From: "Zack, Dino" <Dino.Zack@aecom.com>
To: "Linda Ross" <lcross@gw.dec.state.ny.us>
CC: "Perkins, John" <johnperkins@tycoint.com>, "Eric Frauen" <etfrauen@bizwi...>
Date: 1/5/2010 1:24 PM
Subject: 12/31/09 letter from NYSDEC re: Site No. 915149
Attachments: 12-31-09 letter from NYSDEC.pdf; MW-5 information.pdf

Scott Aviation Site
Site No. 915149
Lancaster, Erie County

The New York State Department of Environmental Conservation (NYSDEC) is in receipt of the Fourth Quarter 2009 Groundwater Monitoring Report dated December 3, 2009.

The First Quarter 2010 submittal of the Groundwater Monitoring Report shall be submitted with the following changes:

FIGURE 2

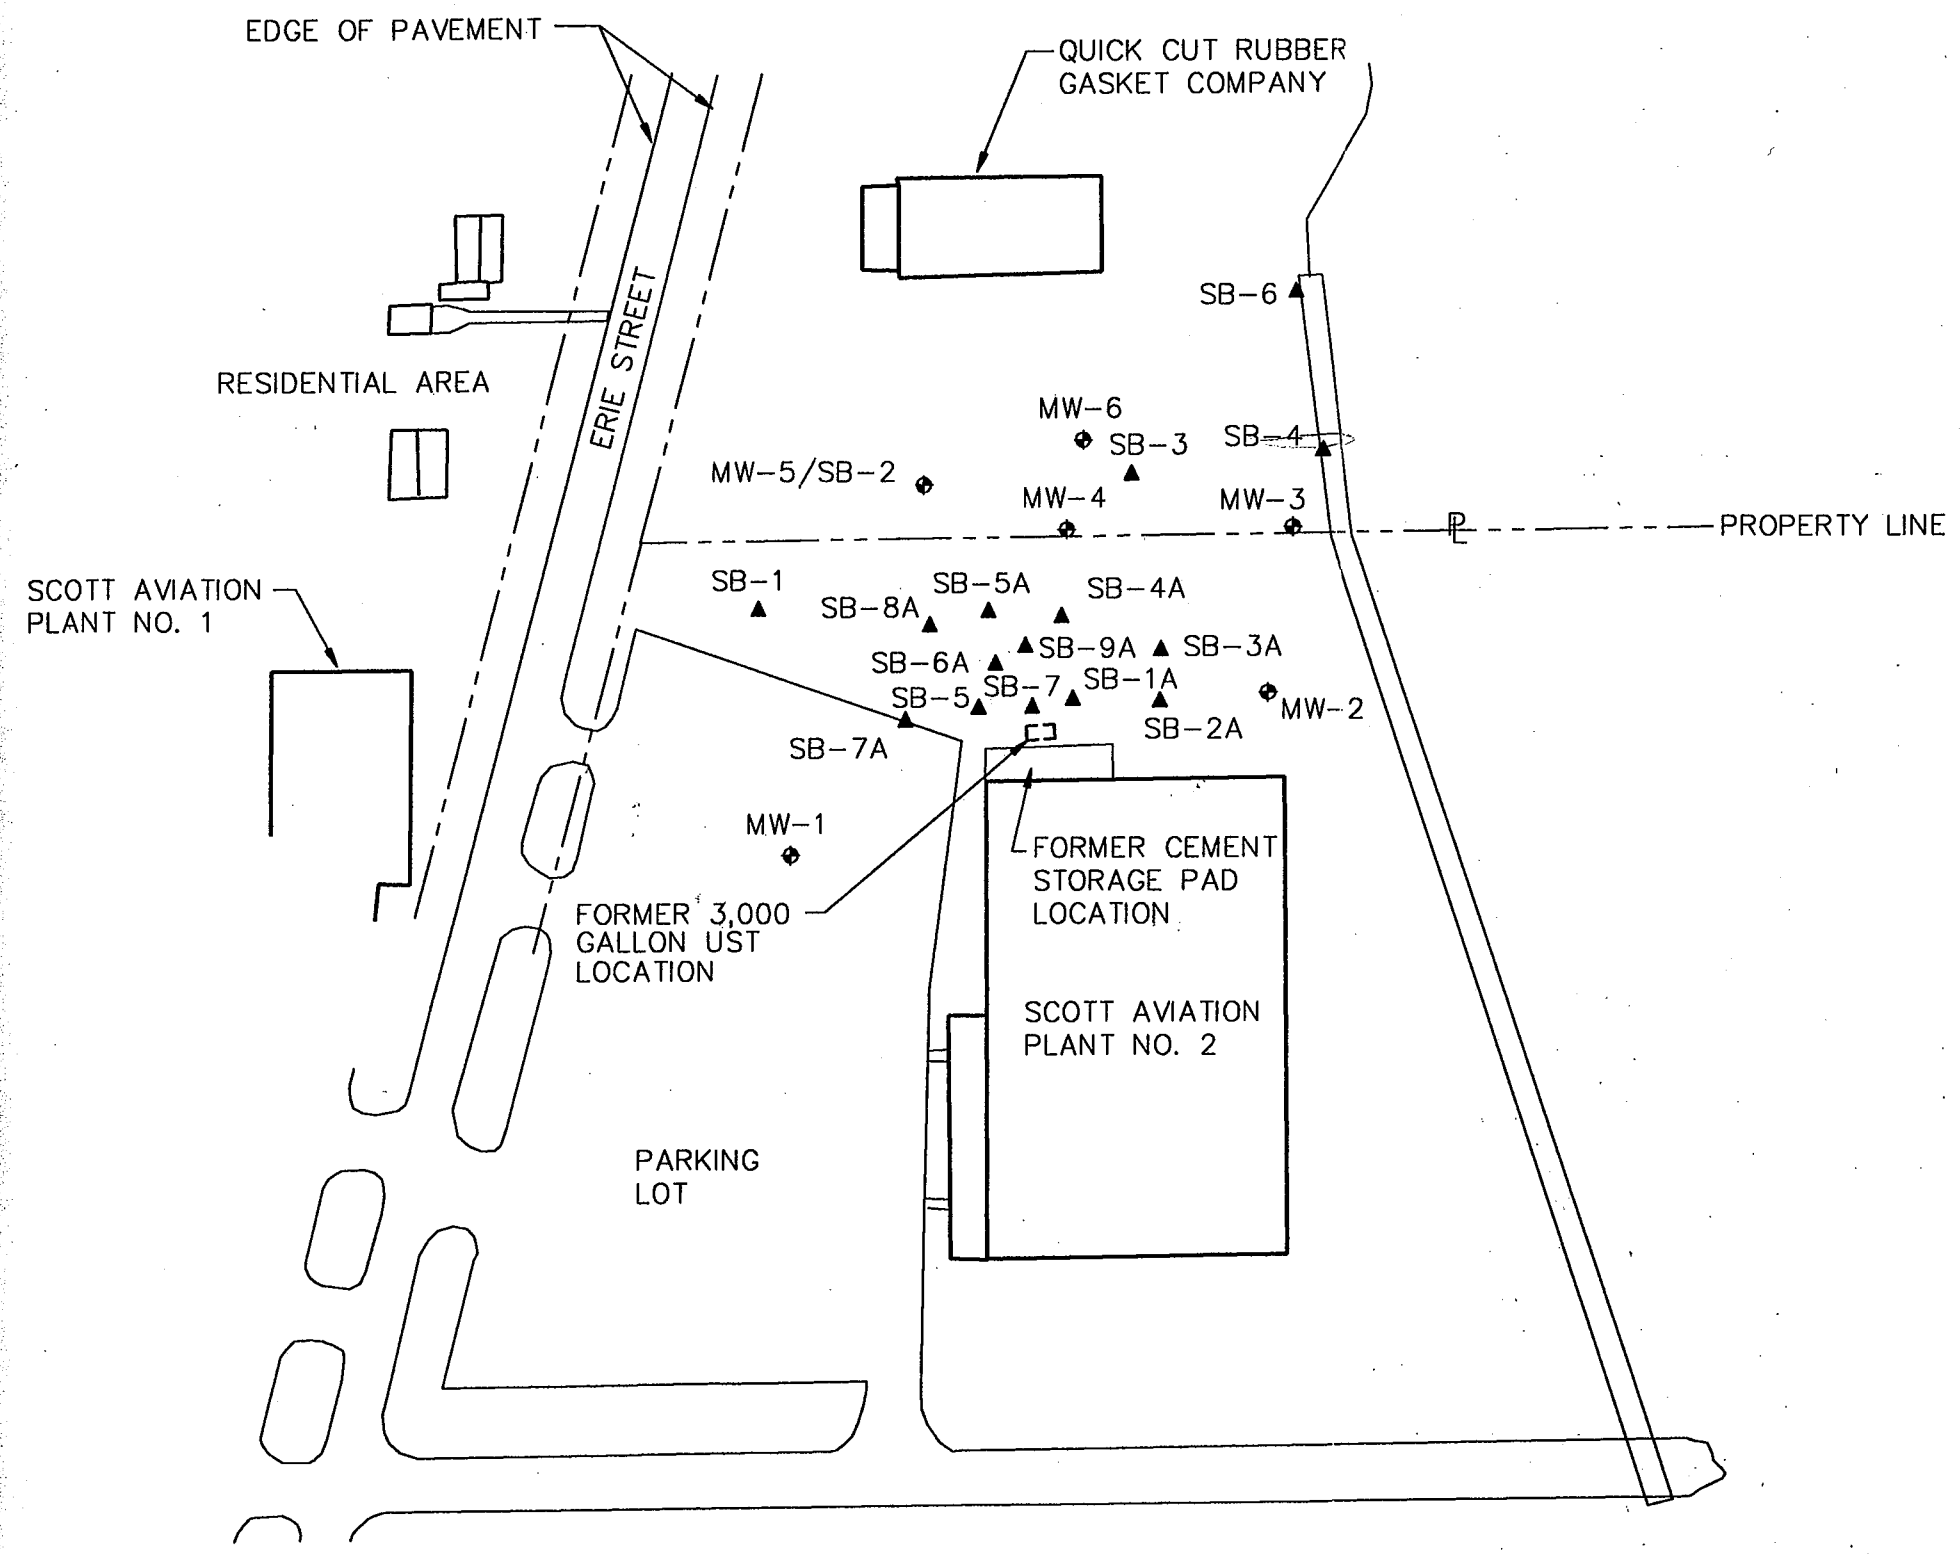
1. Figure 3 - The "Process and Instrumentation Diagram for combined Dual Phase Extraction Remediation System" needs to be updated for current conditions.
2. Appendix C - The "MW-5 Well Inspection Checklist" needs to be resubmitted with a well location figure, well log and two rounds of VOC data (10/20/92 and 11/17/92) as described in the checklist.

1. Figure 3 - "Process and Instrumentation Diagram for Combined Dual Phase Extraction Remediation System" reflects current conditions and does not need to be updated. The figure will be updated if future changes to the remediation process and instrumentation are made.
2. Appendix C - I will include the information you requested for MW-5 in the first quarter 2010 submittal of the Groundwater Monitoring Report. For your convenience, I'm also attaching the information to this email.
